**DOCUMENT 00 90 00
ADDENDUM**

ADDENDUM: 2

DATE: JANUARY 8, 2026

PROJECT: HOUSING AUTHORITY OF THE CITY OF LA CROSSE
2025 CAPITAL IMPROVEMENT PROJECTS
1307 BADGER STREET
LA CROSSE, WISCONSIN 54601
PROJECT NO. 25046

C100

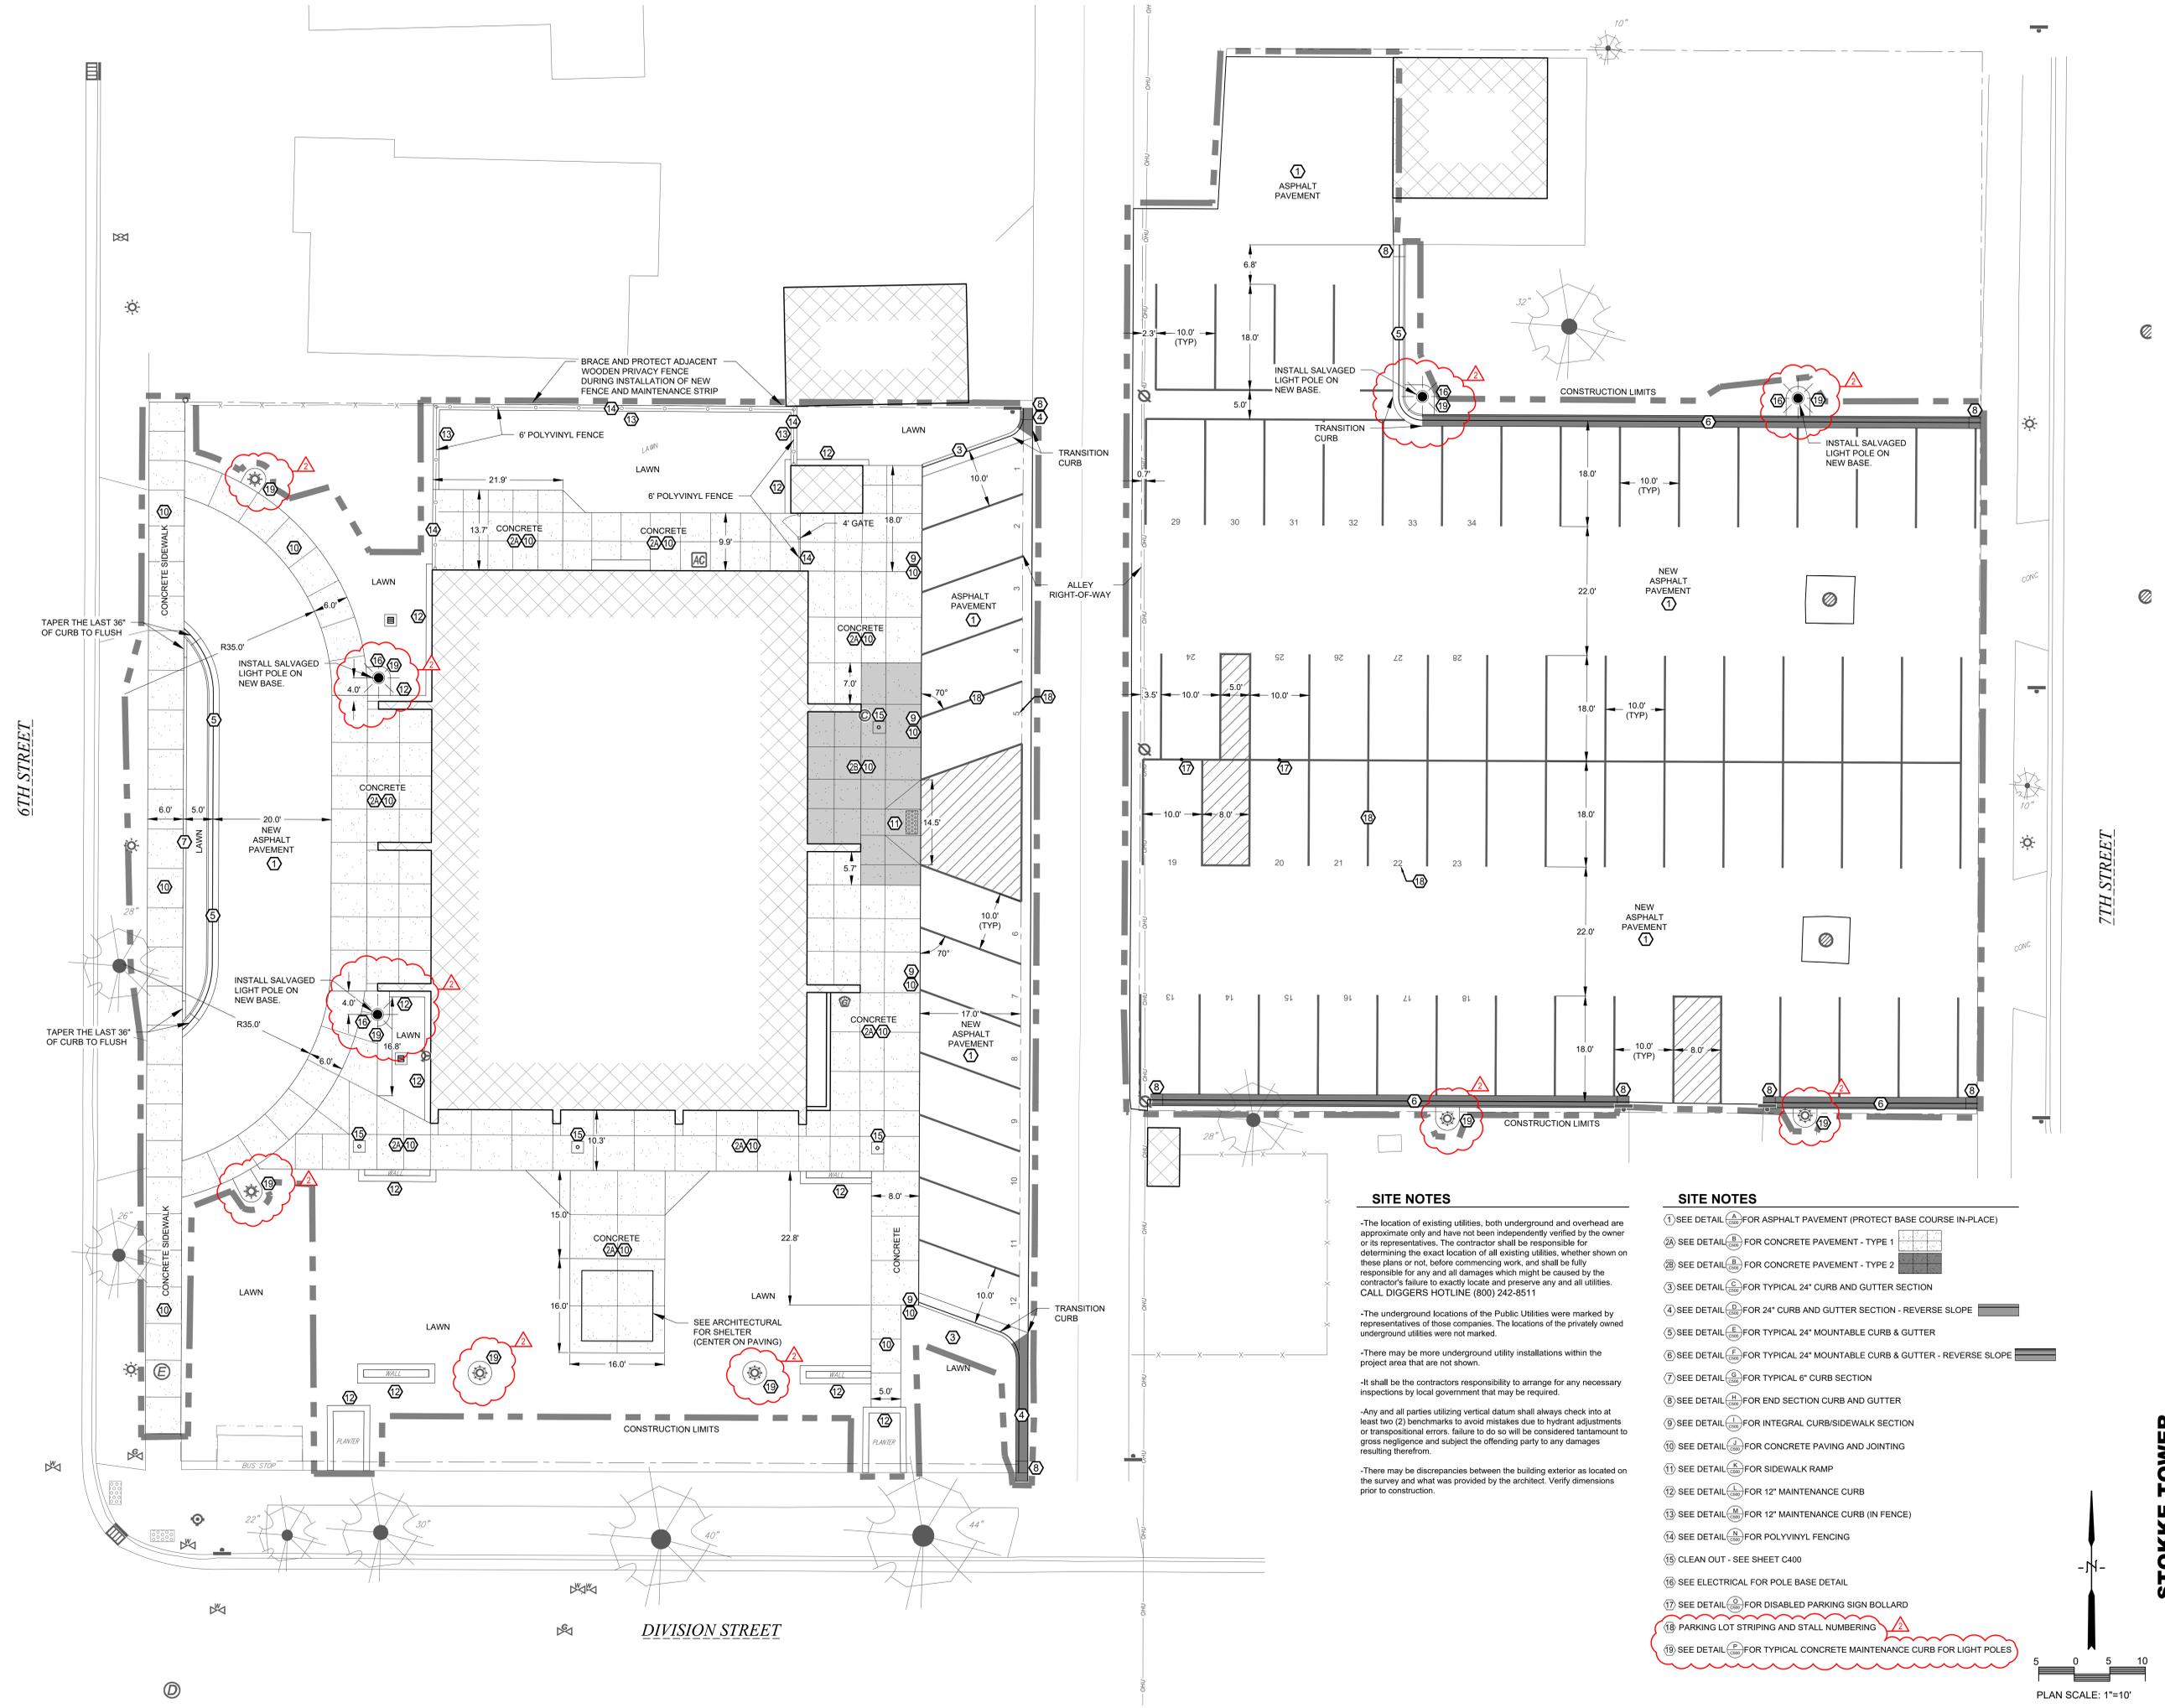
5. Sheet C100 Site PAn - for Stokke Tower 30"x42"
 - a. See the revised sheet included in this addendum. Disregard the previous version.
 - b. Added Site Note #18, "Parking lot striping and stall numbering"

- c. Added Site Note #19, "See detail P/500 for typical concrete maintenance curb for light poles"
 - d. Added linework around site light poles to show extents of concrete maintenance curbing

- e. Added paint numbering on parking stalls
6. Sheet C500 Details – for stokke tower 30"x42"
 - a. See the revised sheet included in this addendum. Disregard the previous version.

P TYPICAL LIGHT POLE MAINTENANCE CURB LAYOUTS
C100 NO SCALE

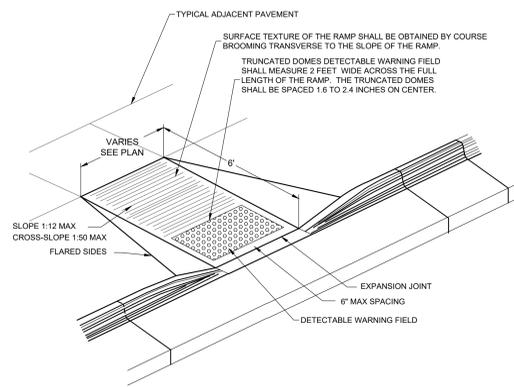
- b. Added Detail "P", Typical Light Pole Maintenance Curb Layouts
7. Sheet C100 site plan – for mullen homes 30"x42"
 - a. See the revised sheet included in this addendum. Disregard the previous version.

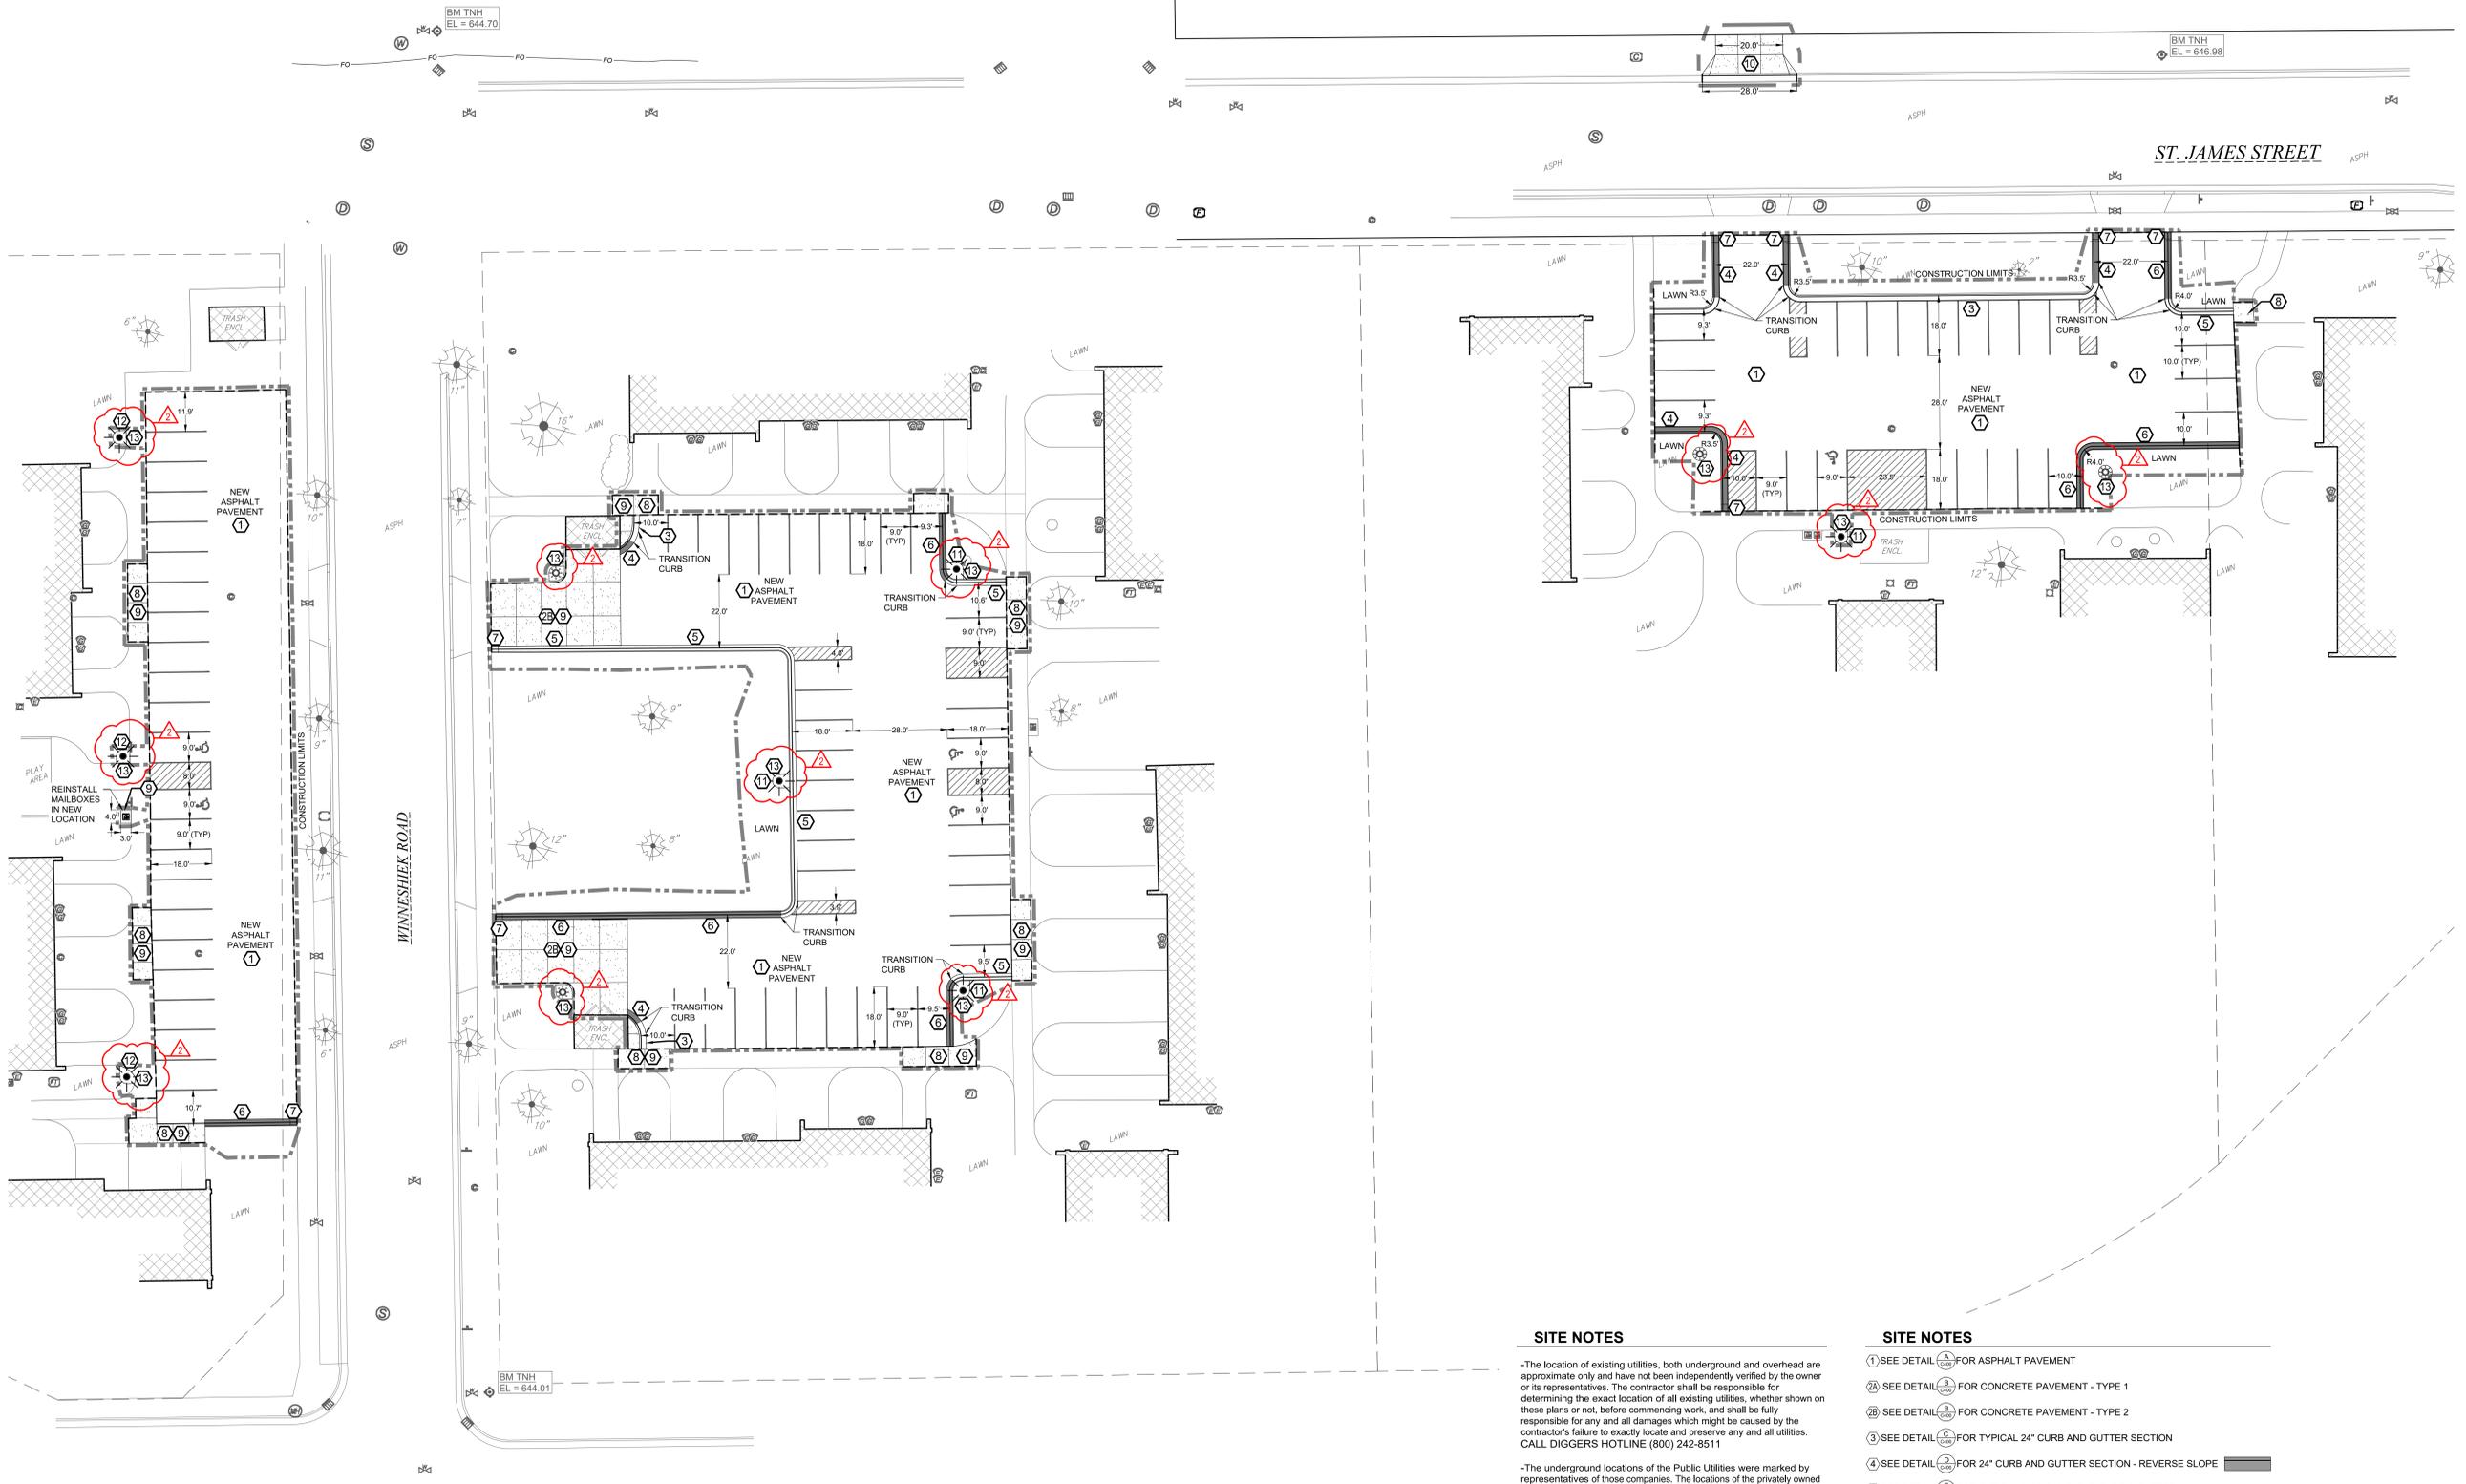
- b. Added Site Note #13, "See details A/C100 and B/C100 for typical concrete maintenance curb for light poles"
 - c. Added Details "A", 12" Maintenance Curb and "B", Typical Light Pole Maintenance Curb Layouts

- d. Added linework around site light poles to show extents of concrete maintenance curbing.
8. Sheet A400 DEMO PLANS 30"x42"
 - a. See the revised sheet included in this addendum. Disregard the previous version.

1 1ST FLOOR DEMO PLAN
1/8" = 1'-0"

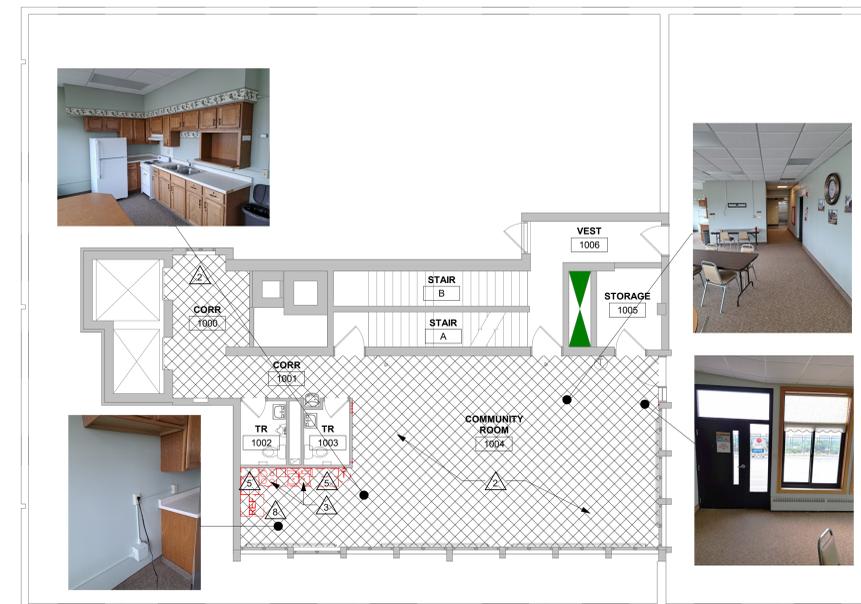
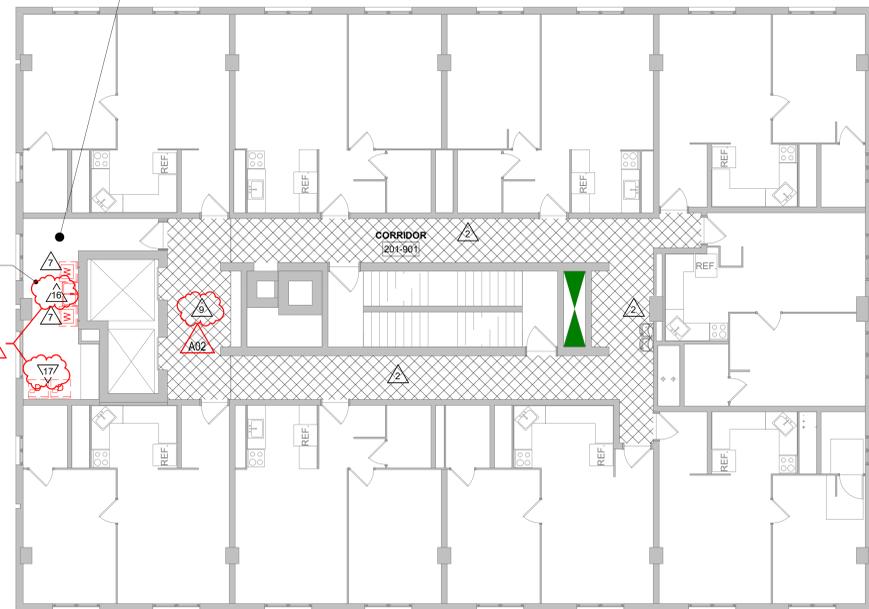
- b. Revised detail 1 including:
 - i. Revised Laundry Room 105 and STG 105A to add ceiling removal area (keynote 14)
 - ii. Added keynote 18 for new ceiling openings.

- c. Revised detail 2 for changes to keynotes at laundry rooms and corridors.
 - d. Revised wording for keynotes 4,5,6,7 & 14.
 - e. Changed the use of keynote 9.

- f. Removed keynote 15.
 - g. Added keynotes 16, 17, 18.
9. Sheet A410 REMODEL PLANS 30"x42"
 - a. See the revised sheet included in this addendum. Disregard the previous version.

A410

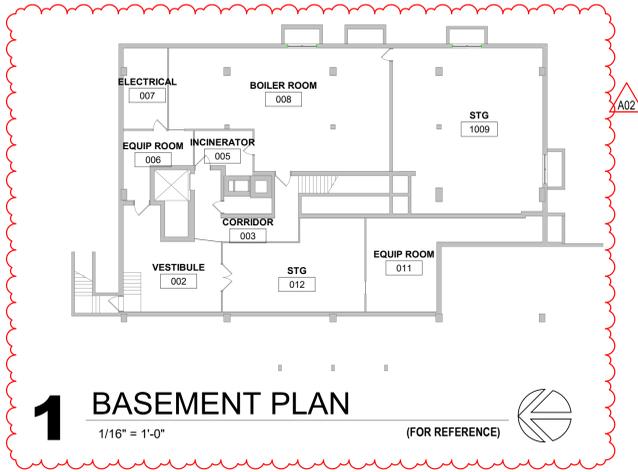
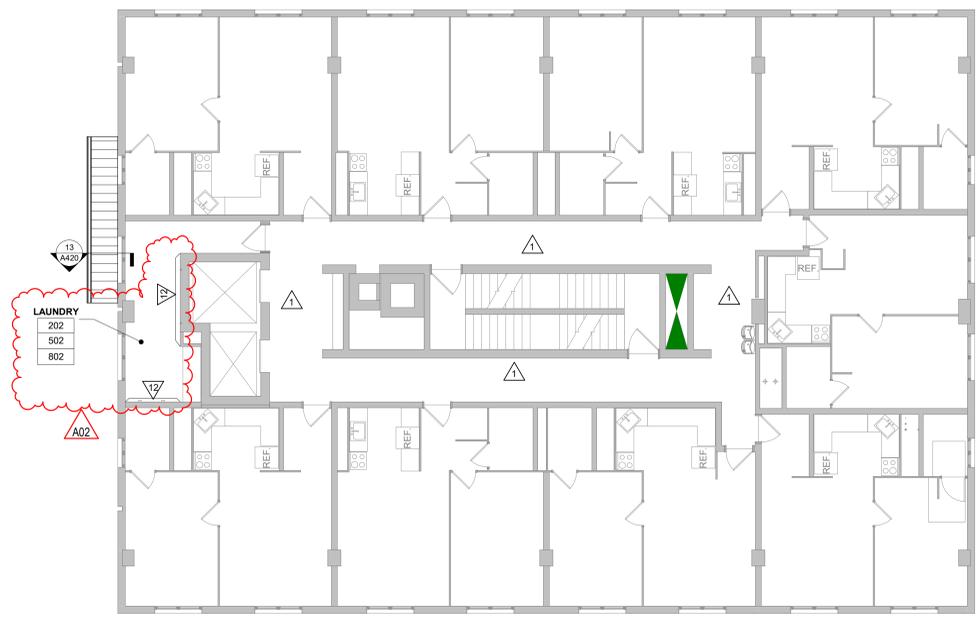
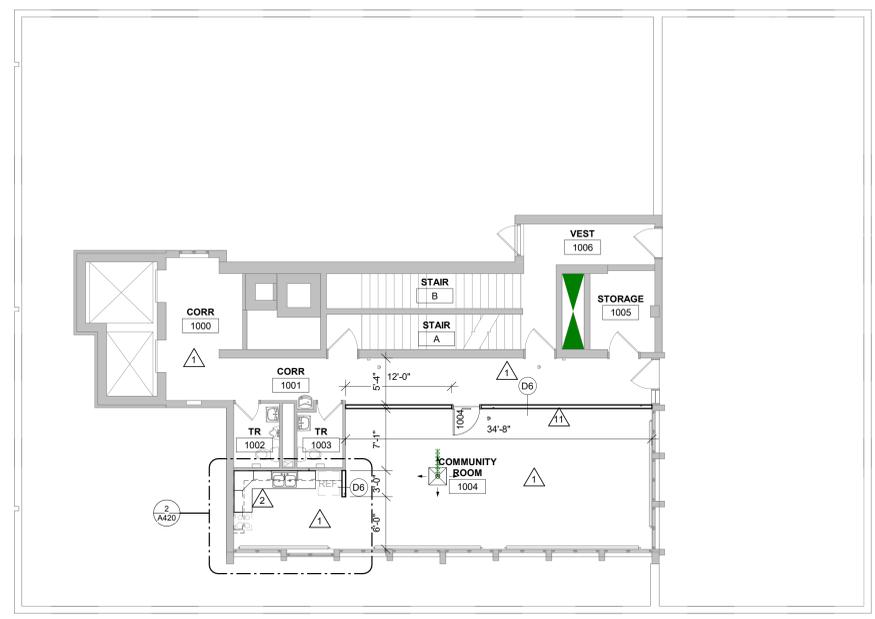
- b. Revised the scale of detail 1.
 - c. Added keynote 12 to detail 3 regarding the abandoned laundries 202, 502, 802.
 - d. Added detail 5 to show laundry room ceiling plan and related notes.

13 AWNING DETAIL
1/2" = 1'-0"

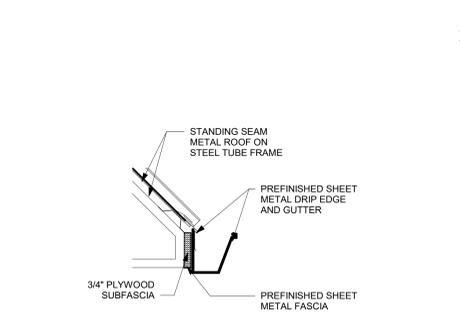
10. Sheet A420 Elevations-Door Schedule-Wall Types 30"x42"
 - a. See the revised sheet included in this addendum. Disregard the previous version.
 - b. Revised detail 12 to lengthen awning to 19'-0".
